গণপ্রজাতন্ত্রী বাংলাদেশ সরকার
শ্রম ও কর্মসংস্থান মন্ত্রণালয়
কলকারখানা ও প্রতিষ্ঠান পরিদর্শন অধিদপ্তর

ক্যাপ পর্যবেক্ষণের তথ্য

কারখানার নাম	শোনন সোরেটারস লিঃ
ঠিকানা	Plot-A-118. S-36, BSCIC, Konabari, Gazipur
কারখানার কোড	GZP309
কালার কোড	
মূল্যায়নের ধরণ: কাঠামোগত মূল্যায়ন	পর্যবেক্ষণের তারিখ: ১২-০৪-২০২৩
১. পর্যবেক্ষণ

সংযুক্তি-সমূহ (৮)

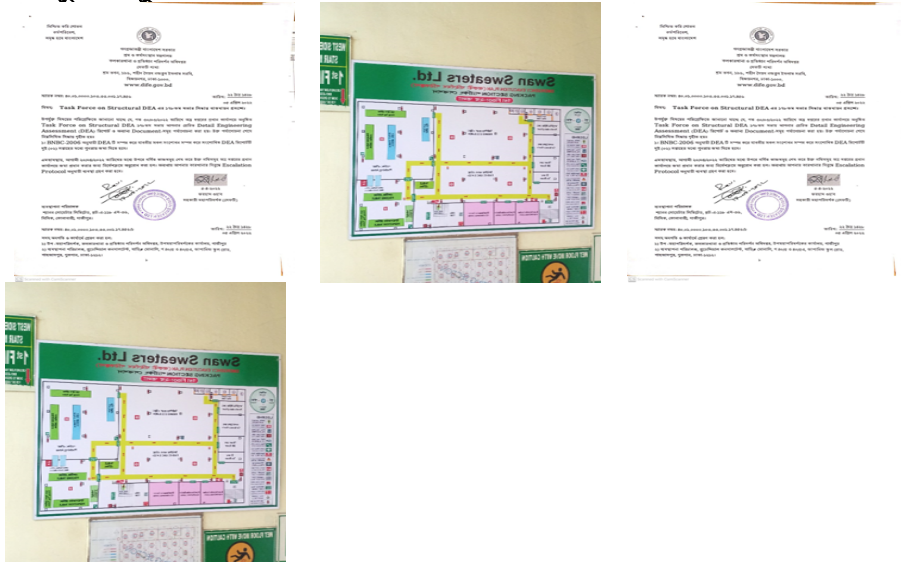
কার্যক্রম	Verify in-situ concrete stresses either by 100mm dia. cores or existing cylinder strength data for identified B6 columns.
সুপারিশের তথ্যসূত্র	
কারখানার কার্যক্রম	
অগ্রাধিকার	প্রযোজ্য নয়
চূড়ান্ত সময়সীমা	-
সংশোধিত সময়সীমা	০১-০১-১৯৭০
অগ্রগতির অবস্থা	সংশোধিত
মন্তব্য	09-April-2019: Core test results have been found on site with different name of the factory. No evidence of core cutting have been observed on site. 07-Nov-2019: Core test results have been found on site with different name of the factory. No evidence of core cutting has been observed on site. 04-Mar-2020: Core test report was found but factory name mentioned in core test report is not matched. Also, evidence of core cutting was not possible to verify due to plastering work. 19.10.2020: DEA report was submitted to DIFE for approval which covers the core test report. But the core test report states different factory name and no core cutting evidence was seen during inspection. 06-01-2021: Core test results have been found on site with different name of the factory. No evidence of core cutting have been observed on site. 10.08.2021: Core test results have been found on site with different name of the factory. No evidence of core cutting have been observed on site. 17.08.2022: Core test results have been found on site with different name of the factory. factory management says that, when the DEA work start & Core has been taken of the building then the factory name is Mega Fashion Wear Ltd. DEA Completion, return for correction & resubmission continue after a long time. in the mean time factory name is change by Shanon Sweater Ltd. Again after a same day factory change name by Swan Sweater Ltd. Also we verify core layout plan. core layout plan are matched with provide core layout plan. 12.04.2023: Completed.
